Number: 737-24A1164
Original Issue: October 03, 2007
Revision 3: May 16, 2014
ATA System: 2450

SUBJECT: ELECTRICAL POWER - Electrical Load Distributions - Installation of the Fire Protection Blanket Around the Raceway Wire Bundles

Revision 3 is sent to inform the operators that the Industry Support Information statement is changed, and to divide the service bulletin tasks into configurations for clarification.

**FIGURE 1: ATTACHMENT OF THE FIRE PROTECTION BLANKET
(SHEET 1 OF 3)**

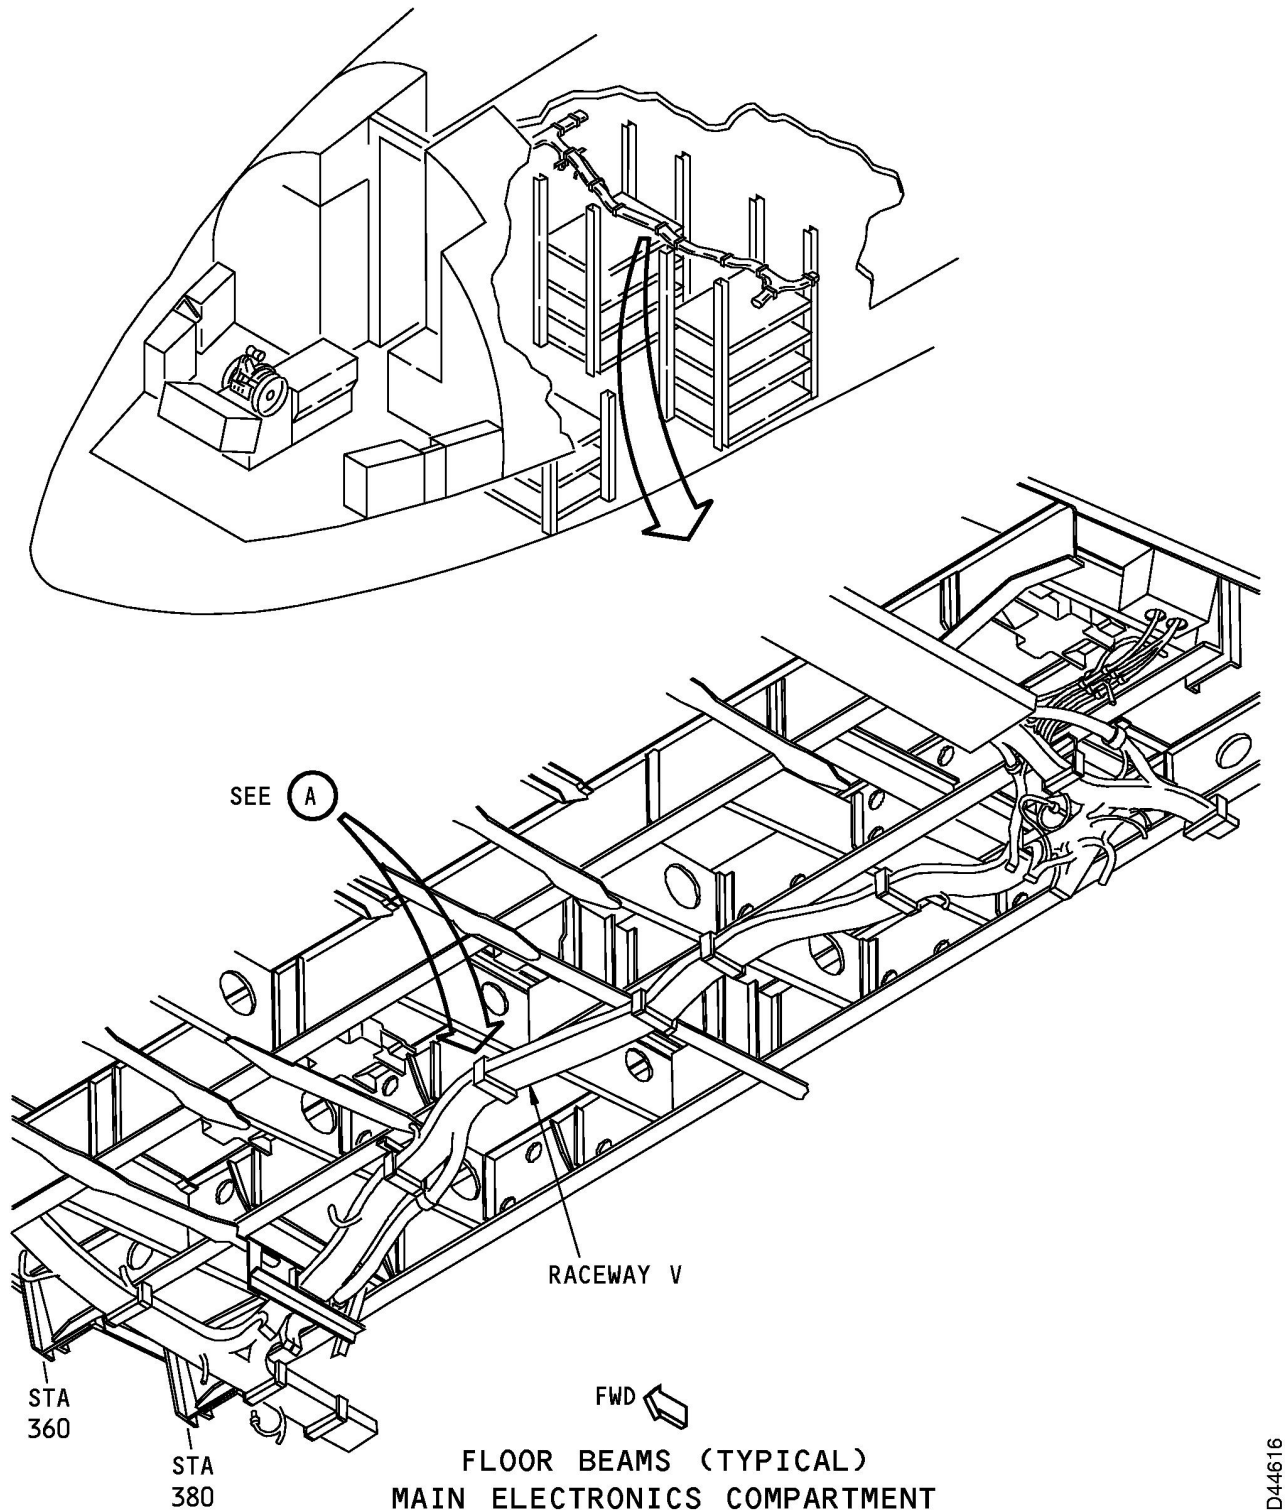
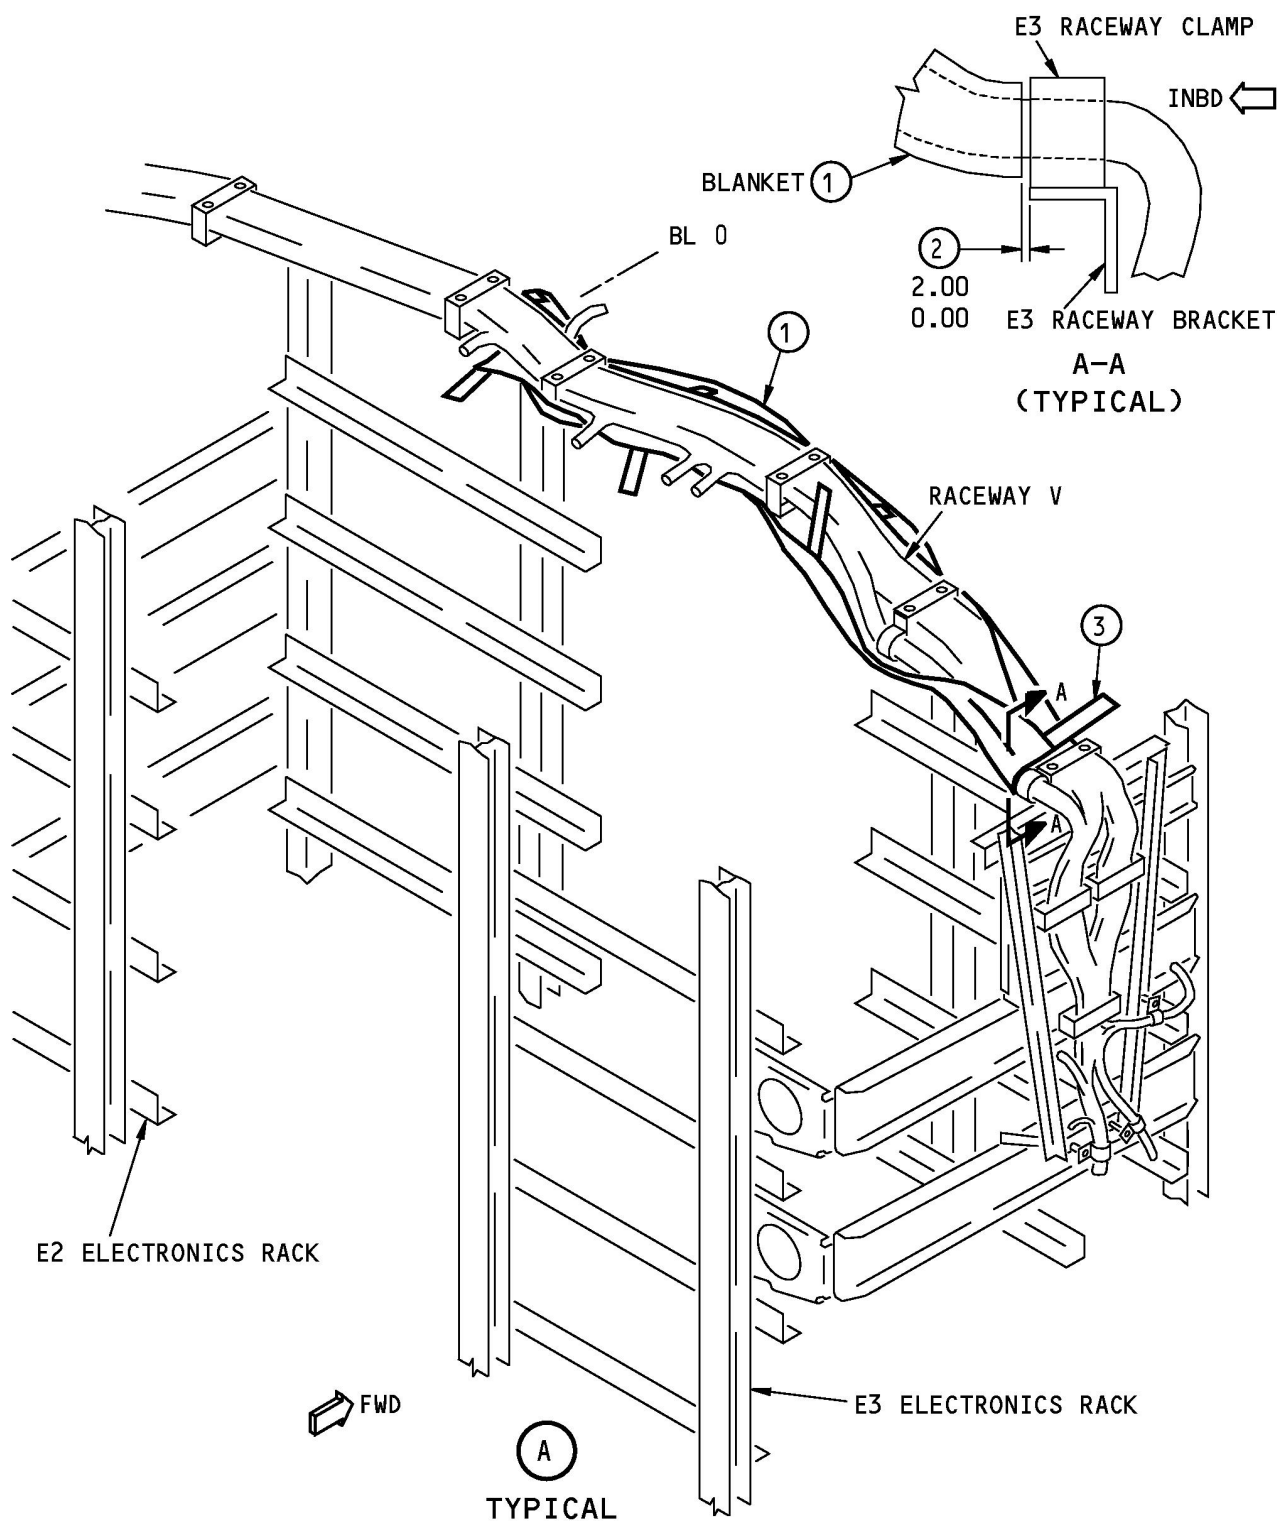
2. Make the changes in the main electronics compartment.
 - a. Above and outboard of the E3 electronics rack, install the fire protection blanket around the raceway wire bundles in accordance with FIGURE 1.

2. Make the changes in the main electronics compartment.
 - a. Above and outboard of the E3 electronics rack, install the fire protection blanket around the raceway wire bundles in accordance with FIGURE 1.

- b. Above and outboard of the E3 electronics rack, install the fire protection blanket around the raceway wire bundles in accordance with FIGURE 1.
 - c. Above and outboard of the E3 electronics rack, adjust the fire protection blanket and install lacing tape in accordance with FIGURE 2.

STEP	TASK	NAME	IDENTIFICATION	QTY	MORE DATA
1	Install (New)	FIRE PROTECTION BLANKET	65C38604-9	1	Around the Raceway wire bundles above the E3 rack.
2	Adjust	FIRE PROTECTION BLANKET	65C38604-9	1	To get the correct clearance from raceway bracket.
3	Connect	VELCRO HOOK	65C38604-5	1	At the location adjacent to the E3 raceway clamp.
		VELCRO LOOP	65C38604-10	1

**FIGURE 2: INSTALLATION OF THE FIRE PROTECTION BLANKET LACING TAPE
(SHEET 1 OF 3)**

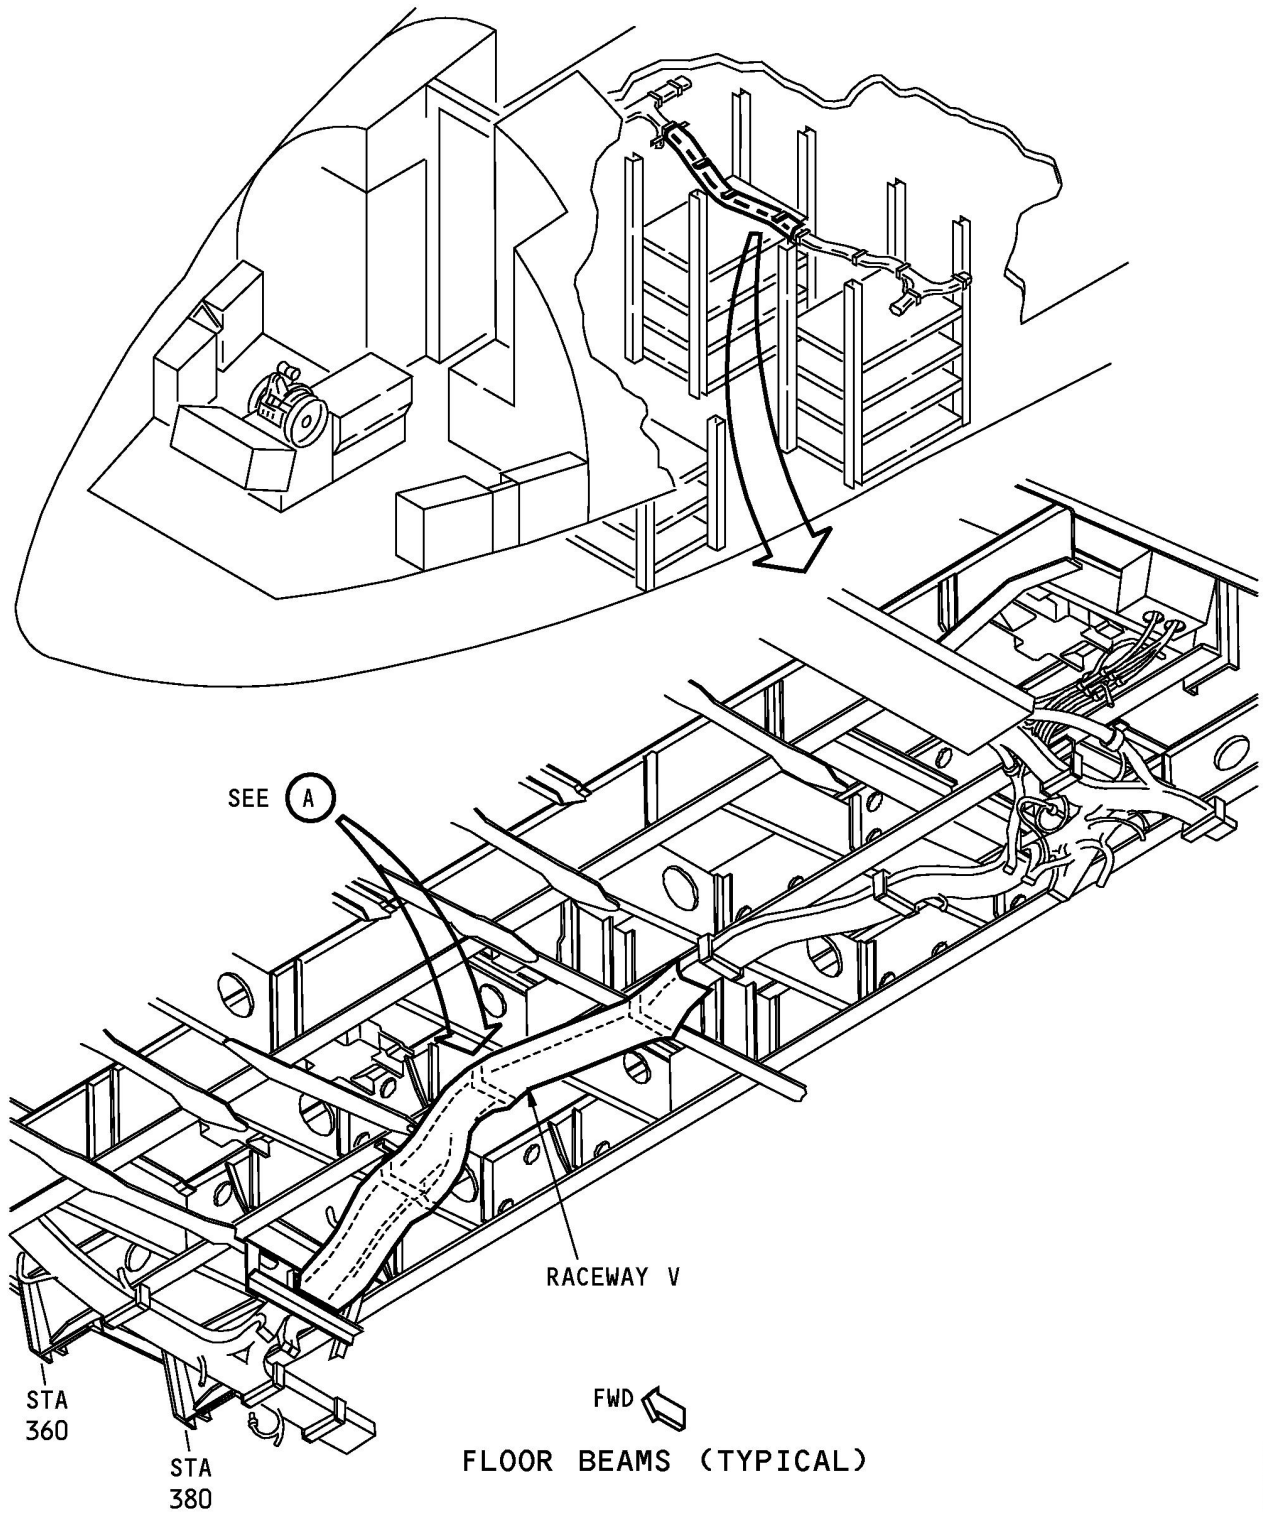
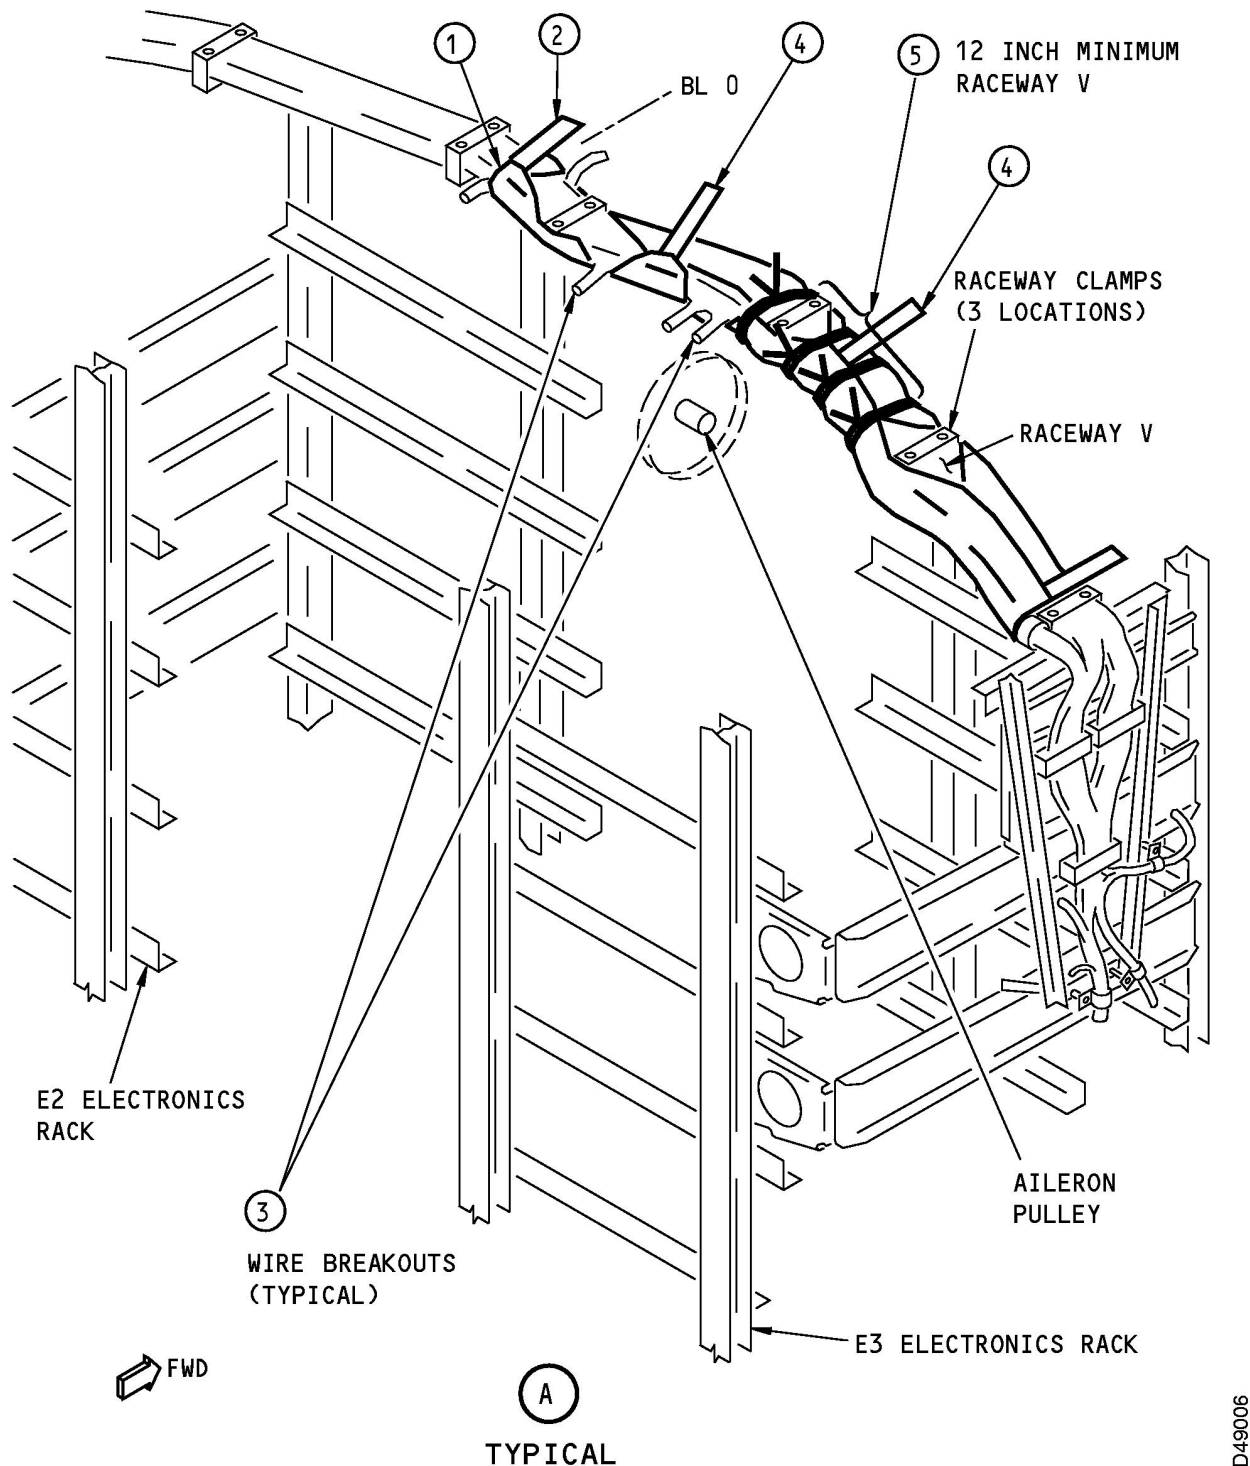
- b. Above and outboard of the E3 electronics rack, install lacing tape around the fire protection blanket in accordance with FIGURE 2.
3. Close access.

- b. Above and outboard of the E3 electronics rack, install lacing tape around the fire protection blanket in accordance with FIGURE 2.
3. Close access.

- b. Above and outboard of the E3 electronics rack, install the fire protection blanket around the raceway wire bundles in accordance with FIGURE 1.
 - c. Above and outboard of the E3 electronics rack, adjust the fire protection blanket and install lacing tape in accordance with FIGURE 2.

2. Make the changes in the main electronics compartment.
 - a. Above and outboard of the E3 electronics rack, adjust the fire protection blanket and install the lacing tape around the raceway wire bundles in accordance with FIGURE 2.

- a. Above and outboard of the E3 electronics rack, adjust the fire protection blanket and install the lacing tape around the blanket in accordance with FIGURE 2.
3. Close access.
 - a. In the main electronics compartment, above the E3 electronics rack, install the kept the moisture shroud. Refer to 737-300/400/500 AMM 25-51-01 as an accepted procedure.
 - b. In the forward cargo compartment, install the kept forward right bulkhead lining and close access to the equipment cooling fan. Refer to 737-300/400/500 AMM 21-58-12 and 737-300/400/500 AMM 25-52-81 as accepted procedures.
 - c. Close the forward cargo compartment door. Refer to 737-300/400/500 AMM 52-31-00 as an accepted procedure.
 - d. Close the access door of the main electronics compartment. Refer to 737-300/400/500 AMM 52-48-41 as an accepted procedure.
4. Put the airplane back to a serviceable condition.
